Agenda Item C.2 CONCEPTUAL REVIEW Meeting Date: October 28, 2025

**TO:** Goleta Design Review Board

SUBJECT: 6595 Covington Way (APN 077-160-022) New Anthem Church

DRB MEMBER COMMENTS

CONCEPT ELEVATION WEST

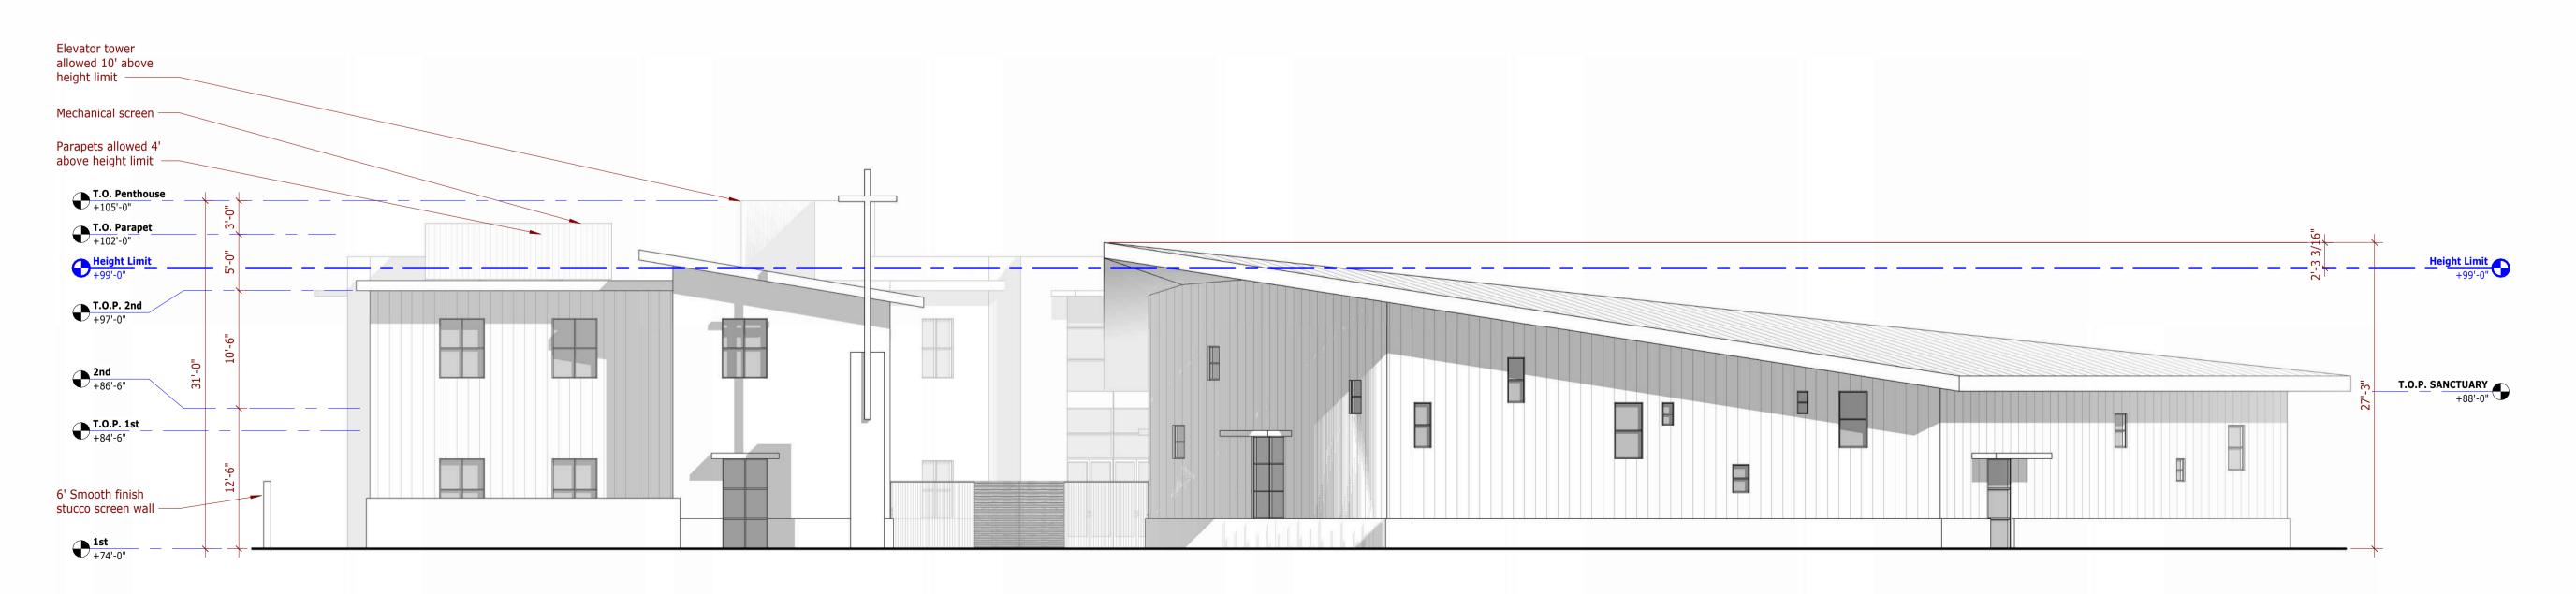
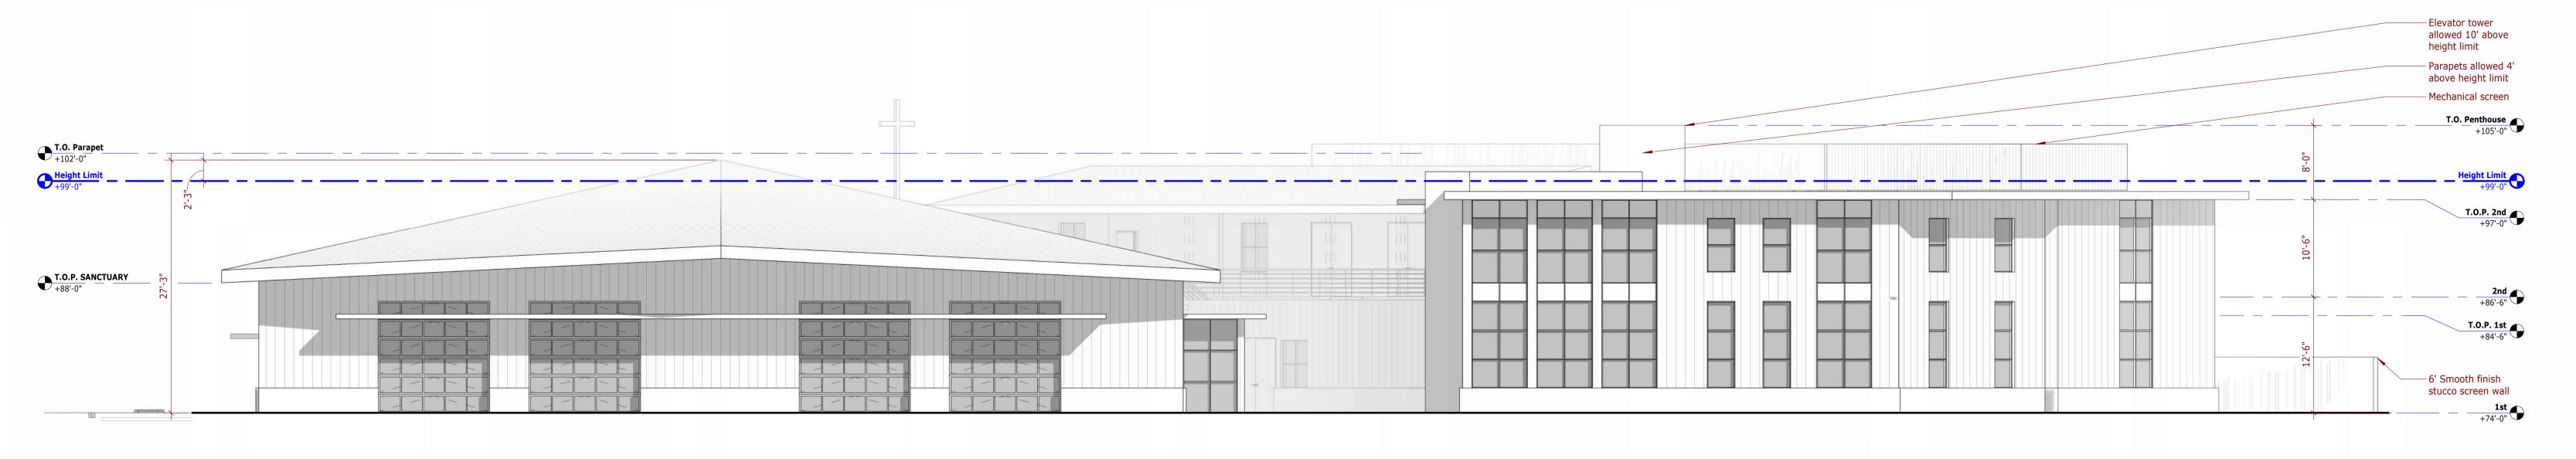
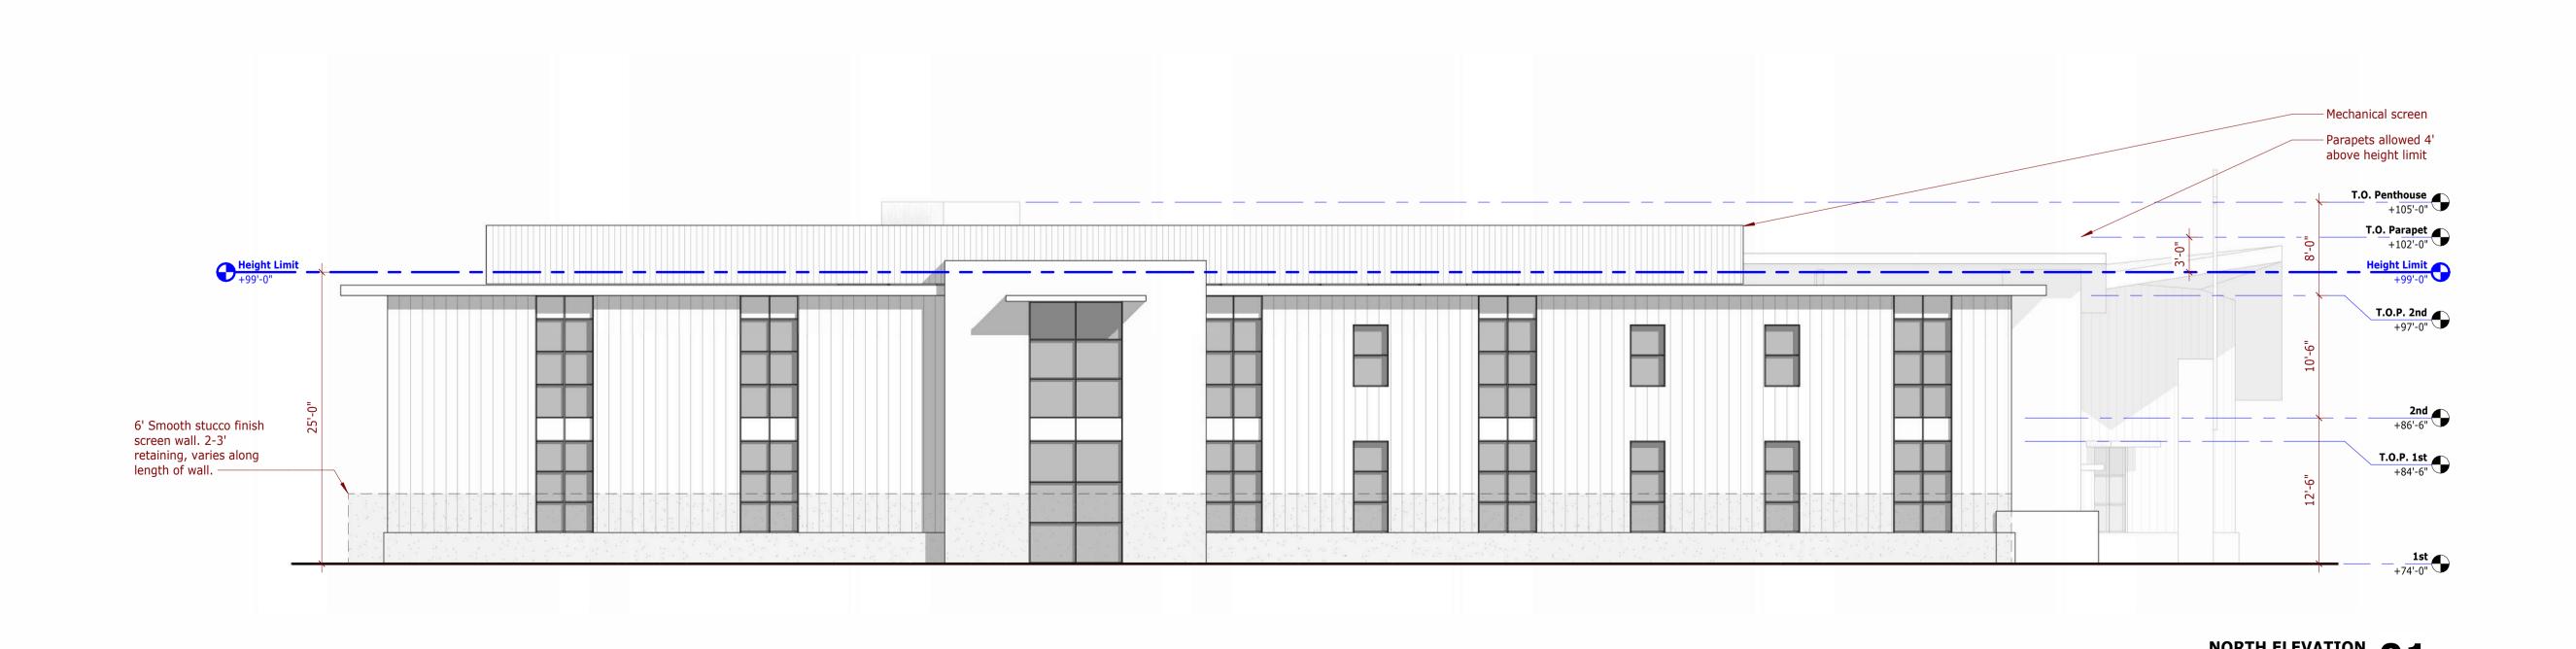
- -North Elevation does not have a relationship to the other elevations
- -Encourages architect to look at the mid-century and modern churches of Goleta for precedent, not agrarian vernacular

- -Does not like the sloped parapets
